Product/Process Change Notice (PCN)

PCN #: WE_LQ_20160920

Product Affected: WE-LQ size 1812 series

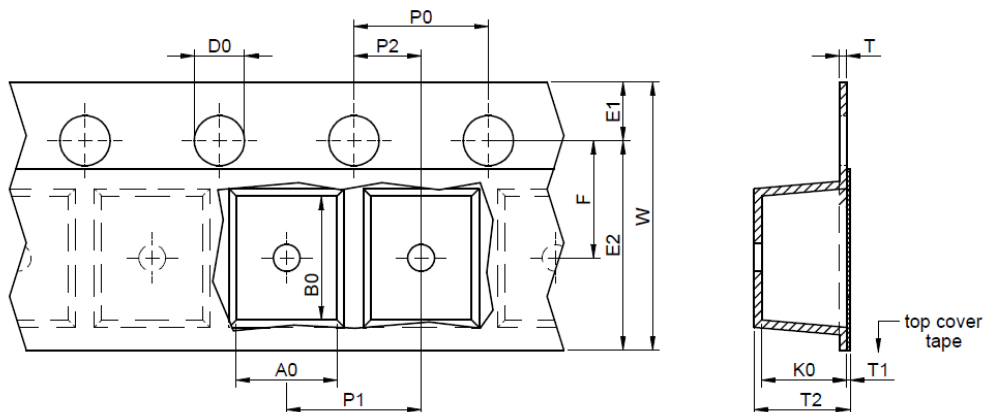
In order to improve the quality of transportation, the cavity of the carrier tape will be changed to reduce the movements and avoid wrong positions in the carrier tape.

The dimension B0 and T2 will be change from 5.00 mm and 3.50 mm, respectively, to 4.80 mm and 3.35 mm, reducing the space at the case where the parts are located into the carrier tape.

Dimension	Before Change	After Change
B0	5.00	4.80
T2	3.50	3.35
